ARCHITECTURAL REVIEW BOARD WORK SESSION AGENDA

Agenda Item: APPLICATION FOR SIGNAGE, ARB #25-003, to consider an application for freestanding signage for the commercial property located near 139 Spring Street, Herndon, Virginia

Subject: APPLICATION FOR SIGNAGE, ARB #25-003, to consider an application for freestanding signage for the commercial property located near 139 Spring Street, Herndon, Virginia.

Original Concept

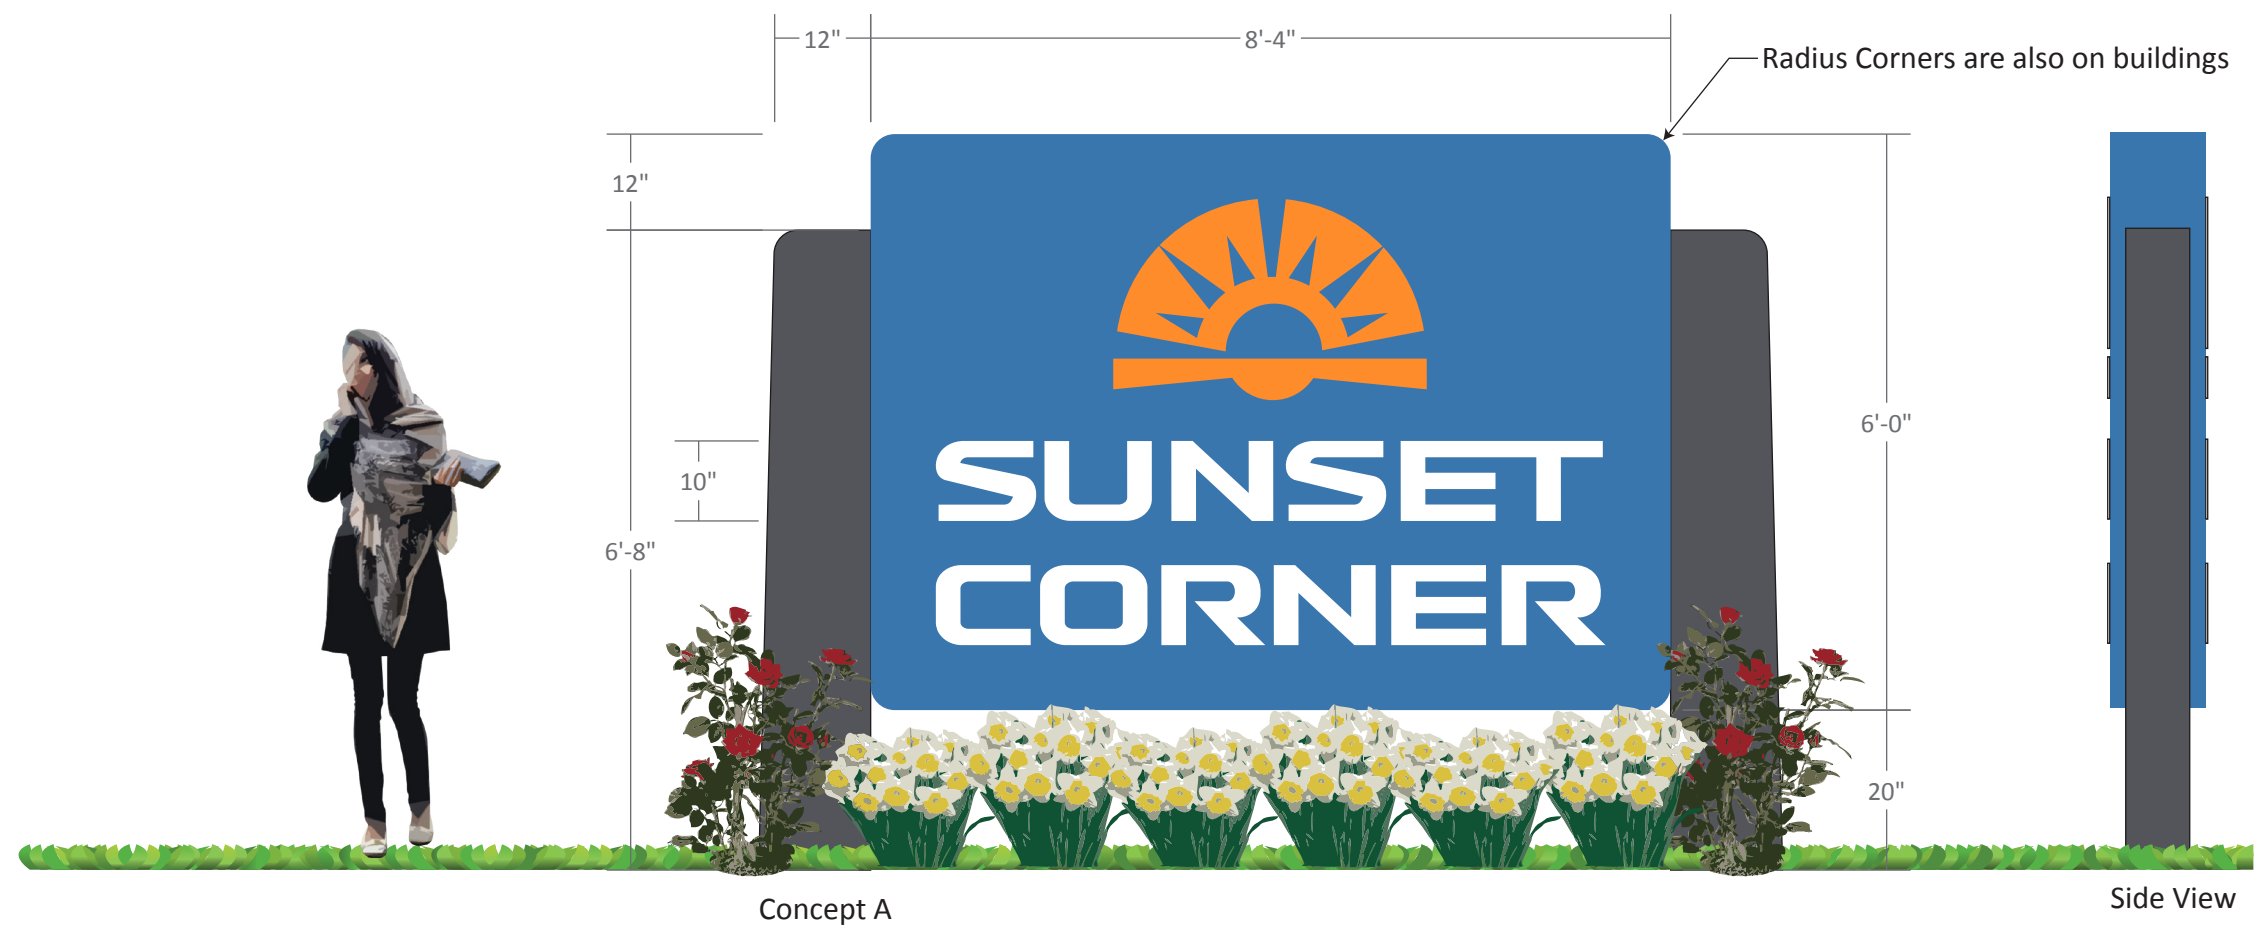
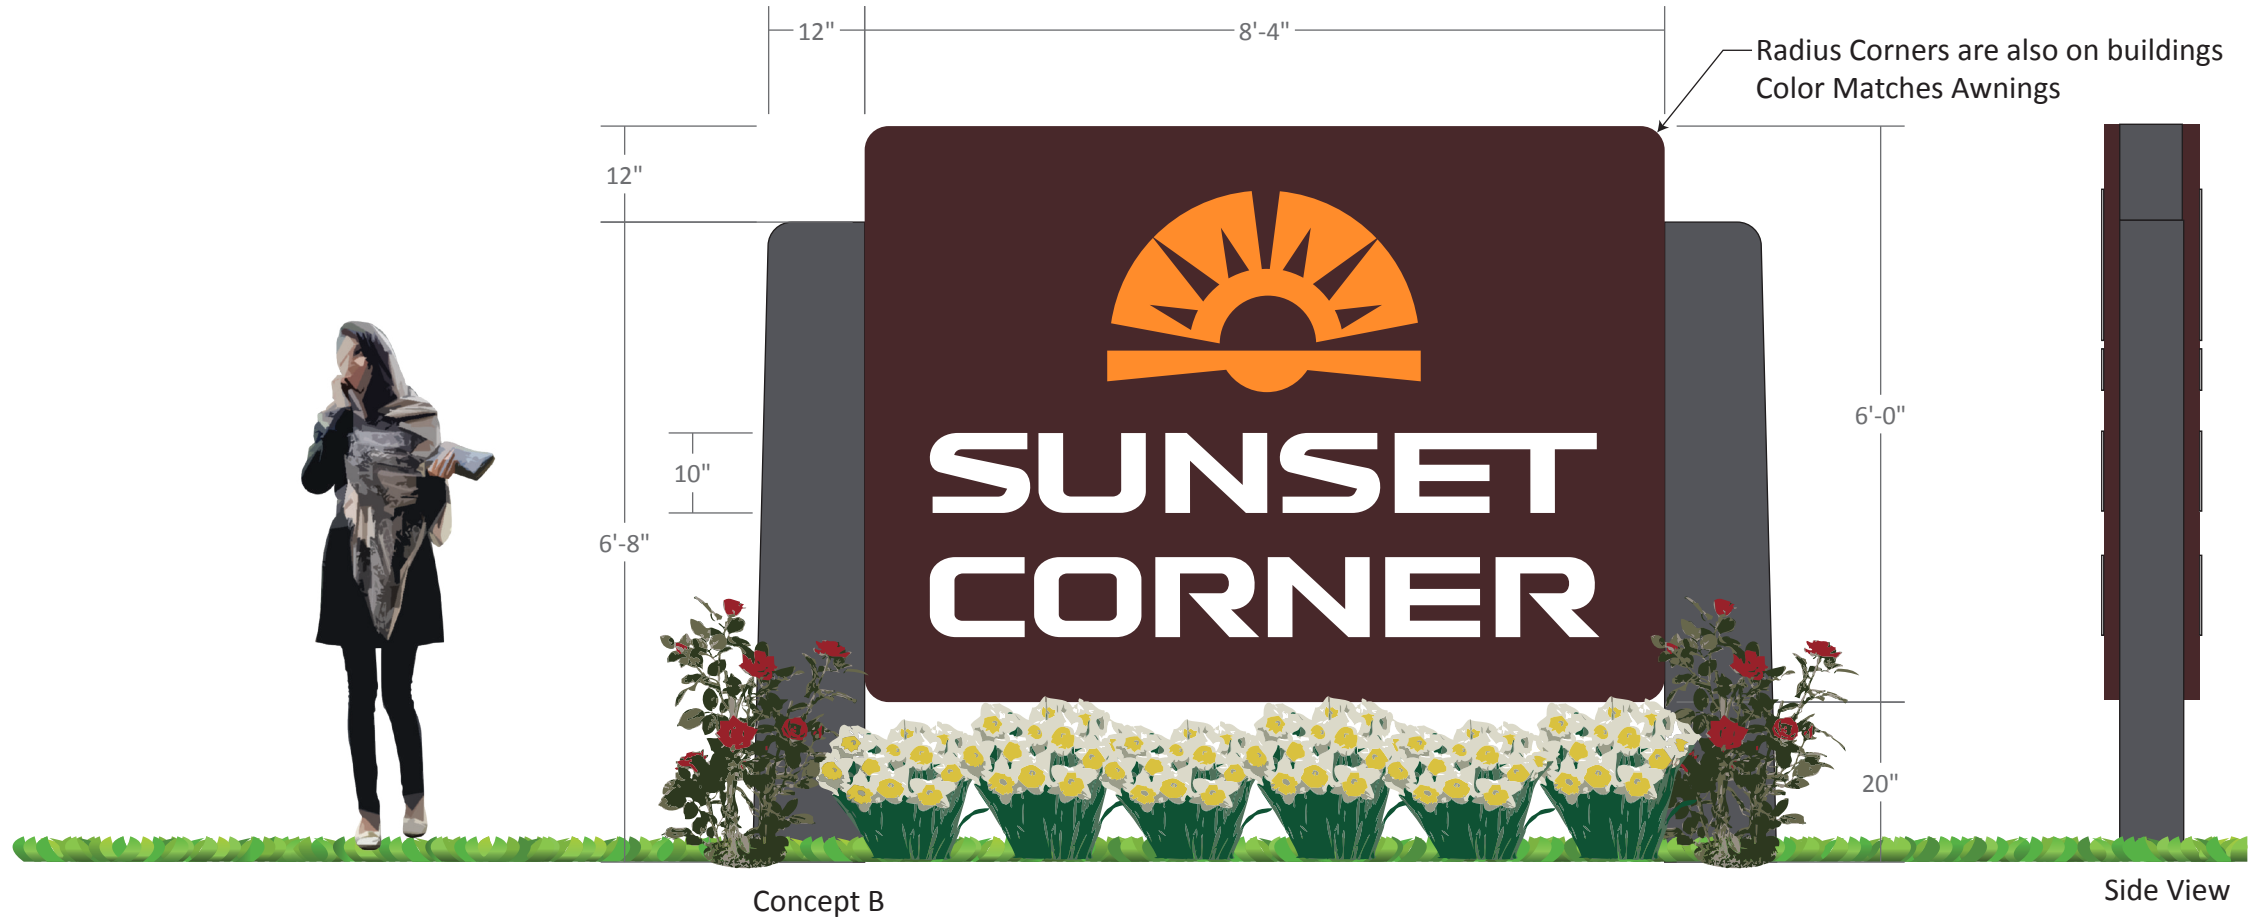
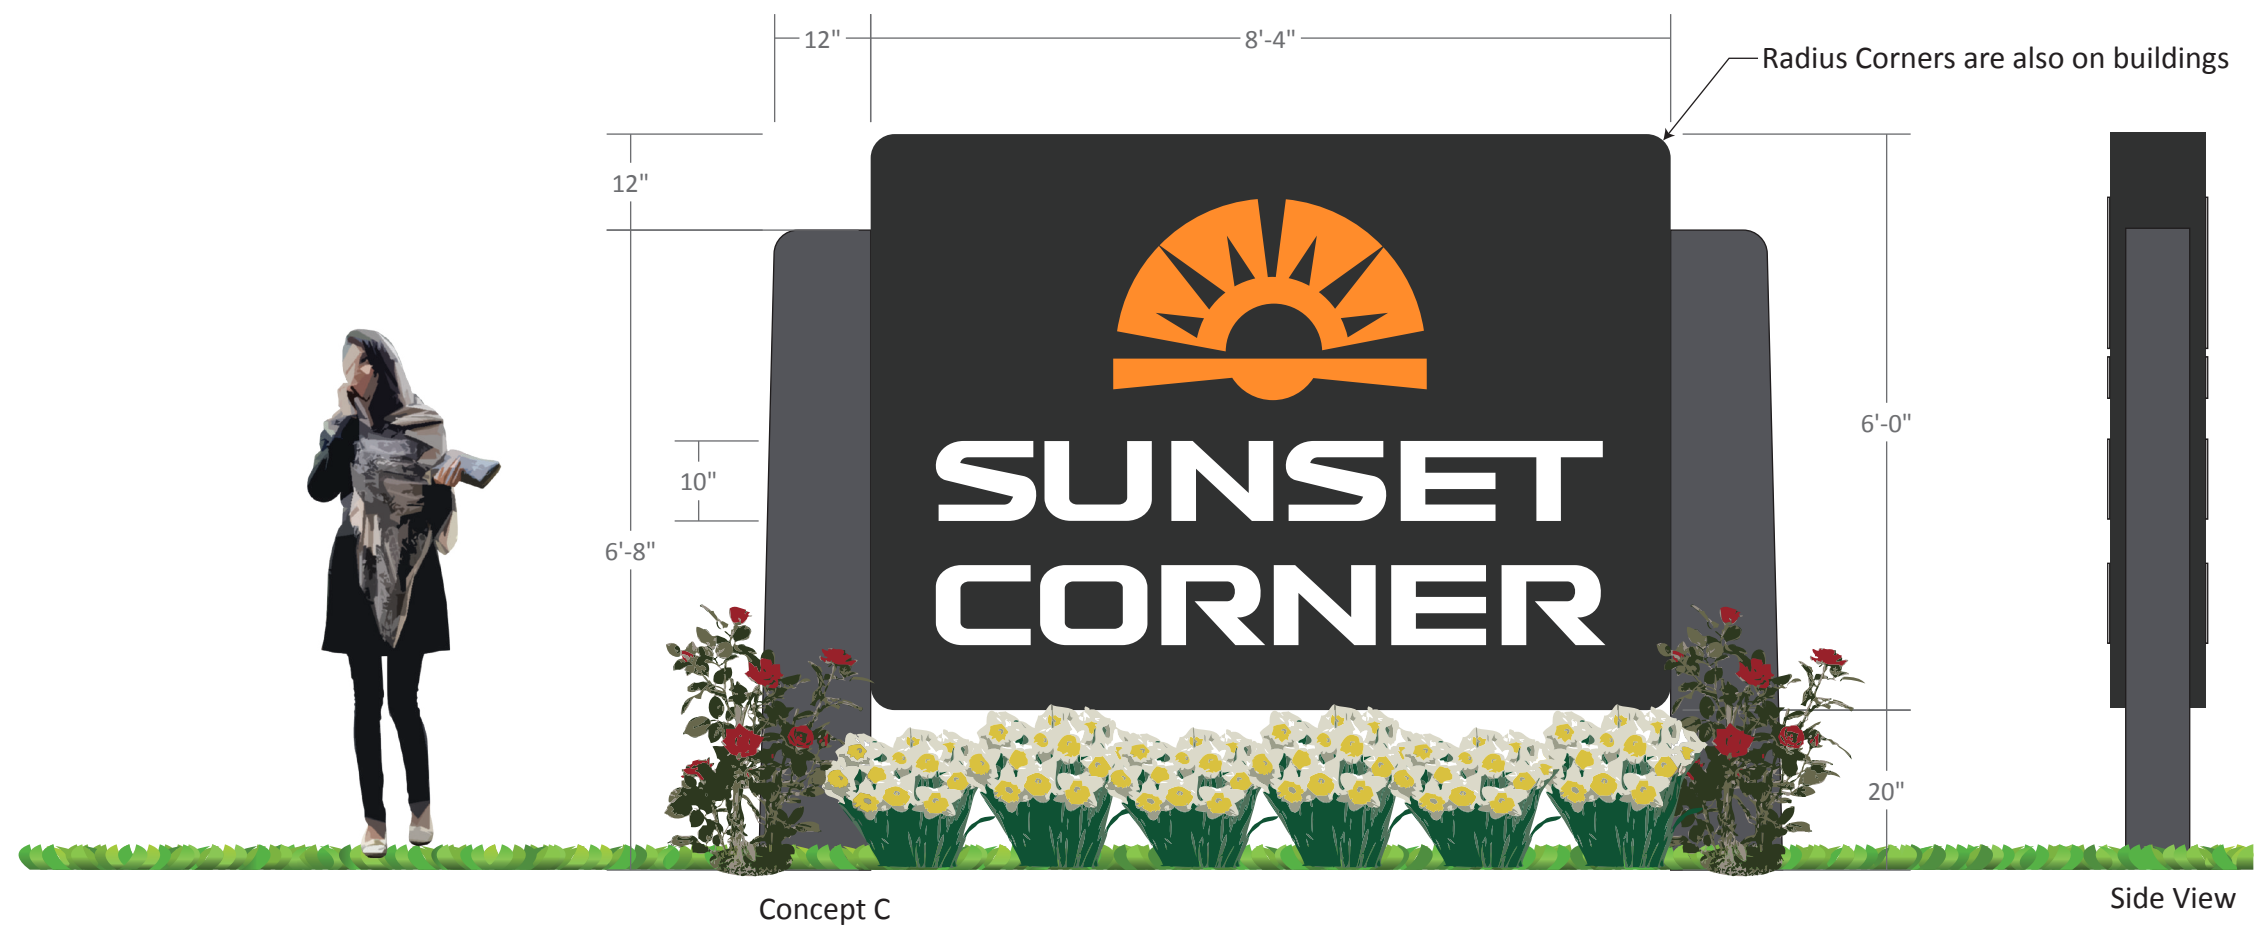
The applicant included preliminary designs for updated signage and digital color swatches as part of the updated materials submitted for the November 12, 2025, work session. The initial design proposed for this location had sharp corners. The revised design submitted in materials for the November 12 work session has chamfered corners that reflect the curvilinear form of the business park's buildings. The applicant has also included example vegetation in the elevation drawings to convey a sense of how the signage will look when the plantings required by the associated site plan waiver are installed (MNP 25-08). Note that the applicant has provided three potential color options for the signs with a preference for the blue and orange scheme depicted on page 2 of the exhibit. The option shown on page 3 depicts a color proposal that would match the maroon of the current awnings and the option on page 4 is a neutral gray meant to be compatible with the existing and possible future awning signage colors throughout the business park.

- The applicant has provided digital color swatches to demonstrate that the proposed blue for the aluminum sign face is an appropriate hue to complement the existing maroon awnings, as well as the renovated building colors if the business park pursues a larger design change in future. While the digital swatches are a helpful reference, staff recommend that the applicant provide physical swatches for the selected colors to be included in the case file. Digital samples are dependent on the resolution and technical specifications of the device on which they are viewed. Physical samples, alternatively, are true to color and a better indicator of the applicant's intended design (please see the related condition in the accompanying draft resolution).

- The updated proposal demonstrates that the proposed colors will be complementary to the existing maroon awnings. The revised design also relates to the overall curvilinear shapes featured in the architecture of the associated business park.

Figure 1: Rendering of the multi-family building included in the GDP.

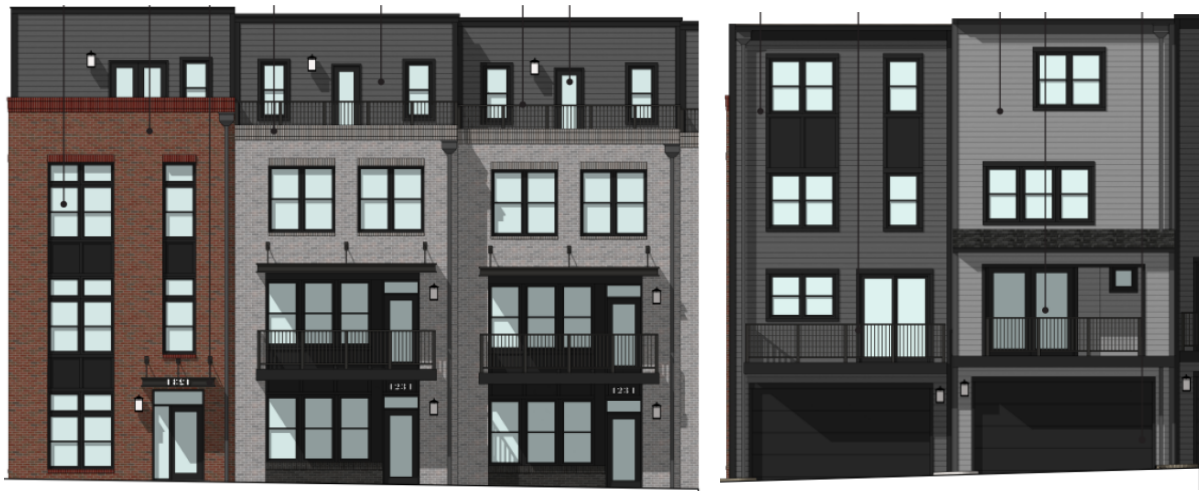
Compatibility with the Multi-Family Building. The revised proposal for changes to the townhouse and stacked condo designs are now consistent with the design of the multi-family portion of the development. As represented in the proffered elevations, the multi-family-building has a varied façade treatment with plane changes that create visual interest and prevent the building's massing from presenting an imposing, monotonous appearance (*Figure 1*). The revised townhouse and stacked condo designs incorporate much of the same materiality as the multi-family building (*Figures 2 and 3*). They also match its contemporary architectural style in both the townhouse and stacked condo designs as demonstrated by the flat parapet roof and the window groupings used for both housing types. While the revised design retains double hung windows and soldier-course brick lintels, the window groupings successfully balance the arrangement of these features across the stick and present a contemporary rather than traditional character. Additionally, the resulting design has a solid-to-void ratio that more closely matches the proffered elevations than the August 6, 2025, submission did.

Townhomes

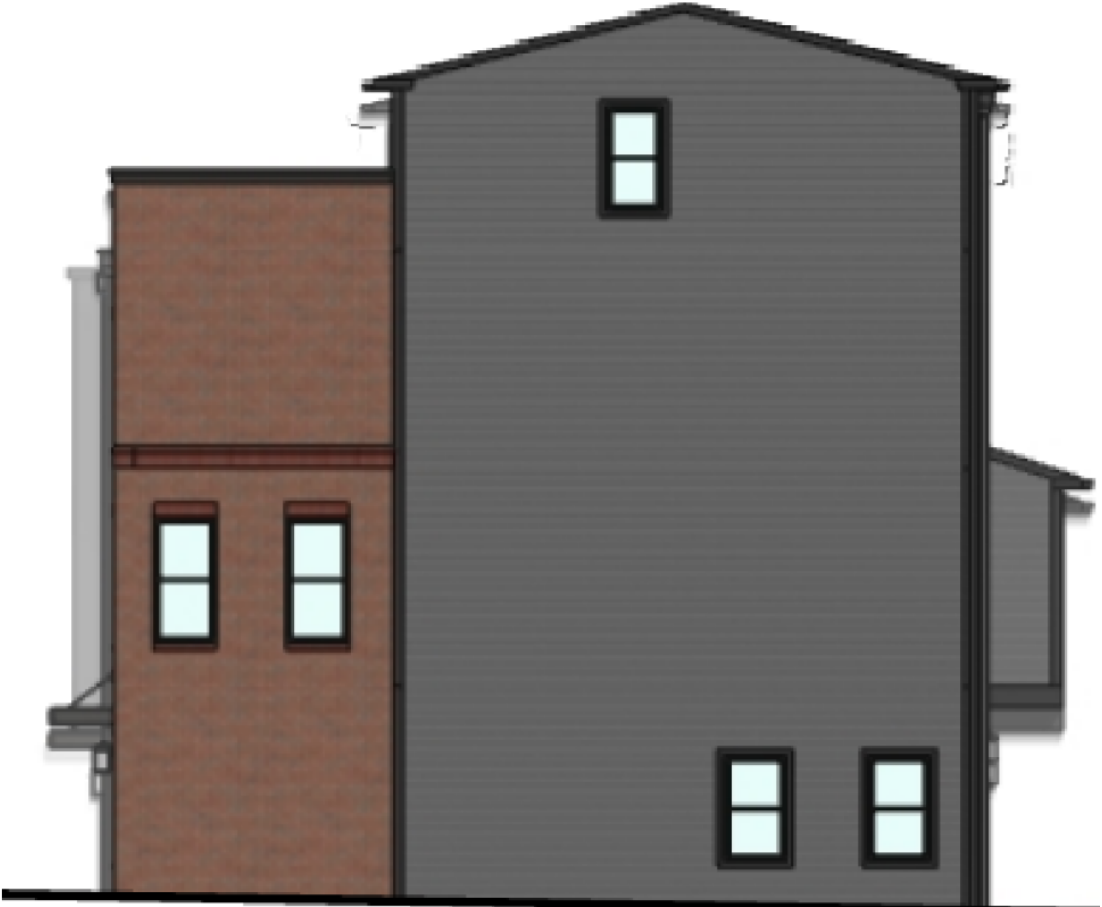
Division of Façades and Massing. The August 6 design proposed changes to the façades of the townhouse and stacked condo buildings that resulted in an overall lack of visual delineation. By contrast, the revised design provides a dynamic façade along each townhouse stick by staggering the placement of walls between units. This effect is accomplished in the stacked condos by selectively stepping the units back as site

Stacked Condominiums

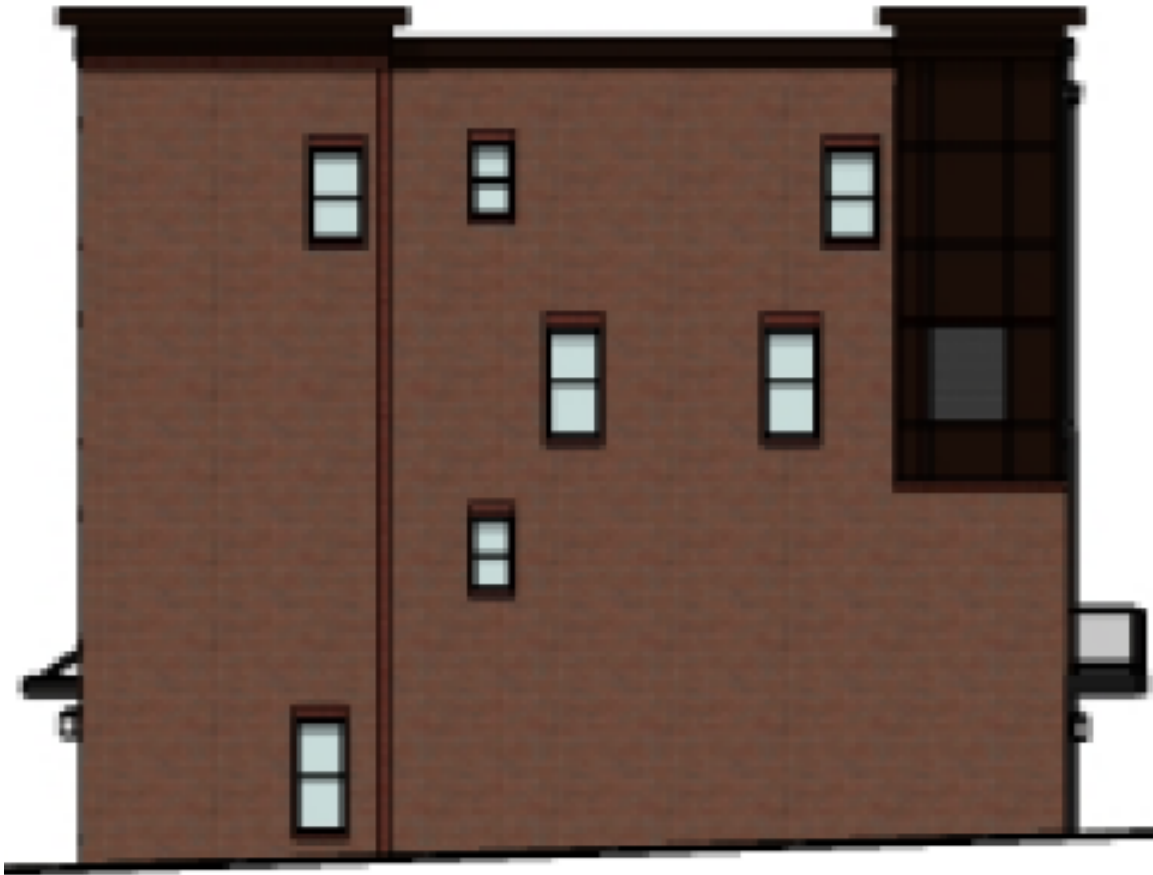
Use of Balconies. The updated design incorporates Juliette balconies on the bookends of the front façades of the stacked condos. The proffered elevations had Juliette balconies in this location, too. These provide a visual break in the window groupings at the ends of these buildings. Furthermore, the revised townhouse design incorporates balconies on the façade. The revised townhouse design also includes a shed roofed, inset balcony on the rear elevation as an option. The other option is an uncovered balcony and both are located over the units' garages. Staff would like applicants to explain if the inset balconies are able to be fully enclosed to provide additional living space or if the intention is to restrict modifications to this feature by occupants after the development is built (*Figure 4 and 5*).

Figure 1: Diagram demonstrating common gable roof pitches, including 6:12 and 8:12. The 12:12 (high pitch) and 4:12 (low pitch) are included as points of comparison.

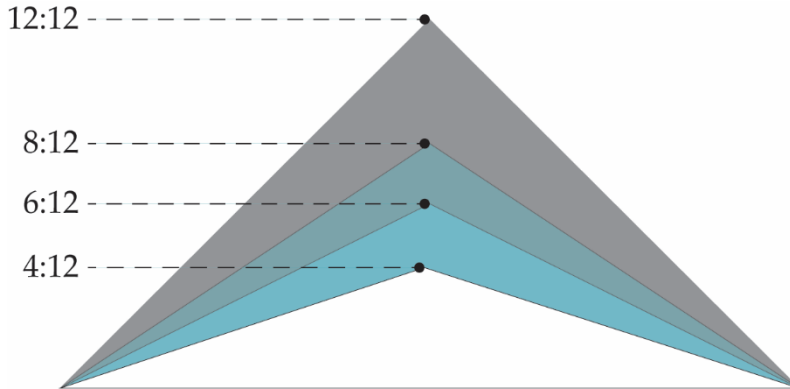
Building Configuration – Roof (p. 4): The standards pertaining to roofs have been updated to specify that either parapet, parapet concealed gable, or gable roofs must be used. However, the standards currently allow for gable roofs with a 6:12 pitch to be unconcealed. This is a relatively low pitch for a gable, and it conveys a prosaic suburban residential design that will be out of place when juxtaposed with the contemporary and innovative design of the multi-family building. Staff maintain that gable roofs with pitches below 8:12 should be required to be concealed by a parapet (*Figure 1*).

Figure 2: Diagram showing elevation type included on page 15 of the Stacked Townhouse Design Standards.

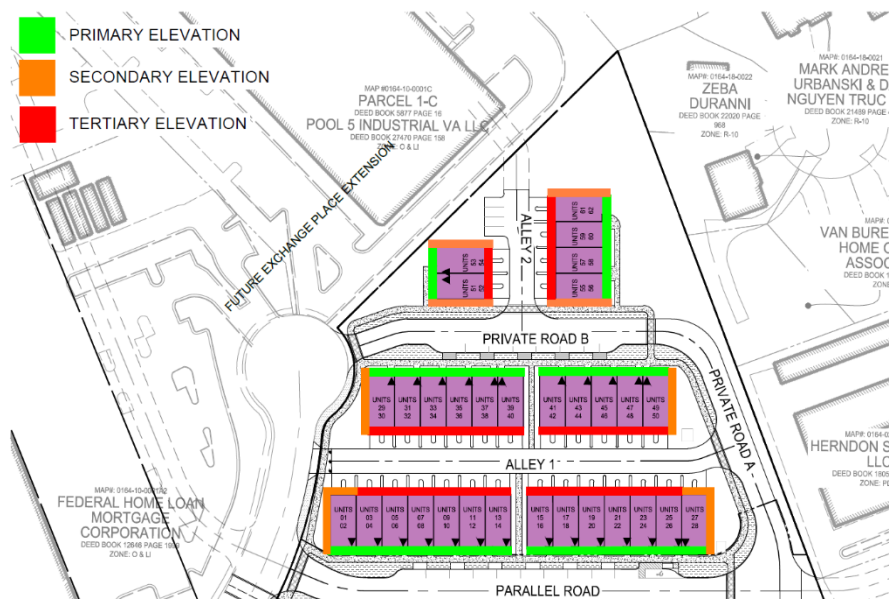
Additionally, the standards currently state that low-pitched gable roofs must be concealed by a parapet on the primary and secondary elevations. This means that the low pitch will be visible from the tertiary elevations, which corresponds with the rear or alley facing sides of this development. The unconcealed portion of the gable will therefore have a high degree of visibility from Private Roads A and B (Figure 2). The standards should be revised to require a parapet to screen low-pitched gable roofs on all sides.
